GTS Newsletter

2010/03E

Machine	TASKI swingo XP
Subassembly	Brush lowering device

Modification brush lowering device / Linear drive

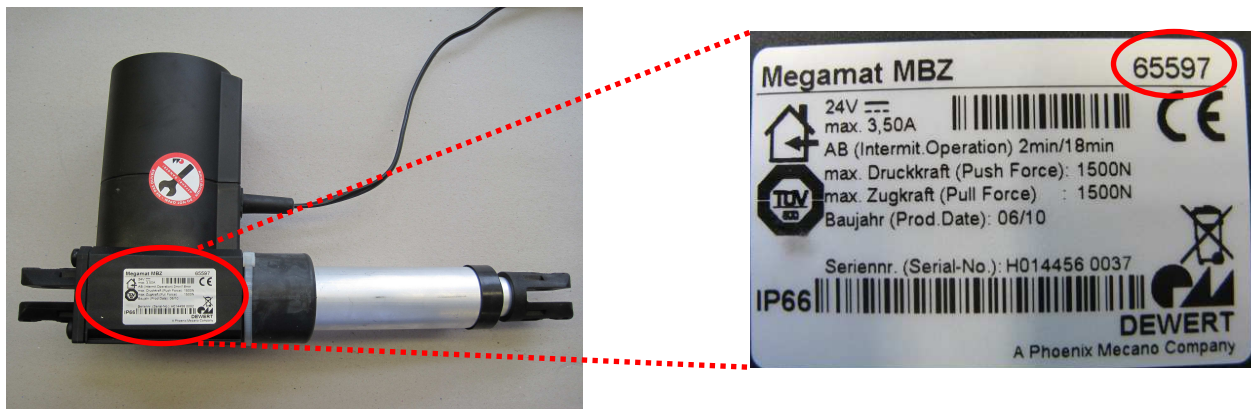
In collaboration with our supplier, a solution could be implemented, which is preventing the contact point of the limit switch within the linear drive from burning down.

To avoid a contact burn down, a suppressor diode will be built in to protecting the limit switch from short term overcharging.

The new version of the linear drive can be identified according to the reference number on the label provided by the supplier. The reference number of the first version of the linear drive was 53347. The updated version is showing reference number 65597 (see picture on the right).

The modified linear drive is backwards compatible and can be ordered under the existing number 4124205 (18600-71).

as of machine number 5425
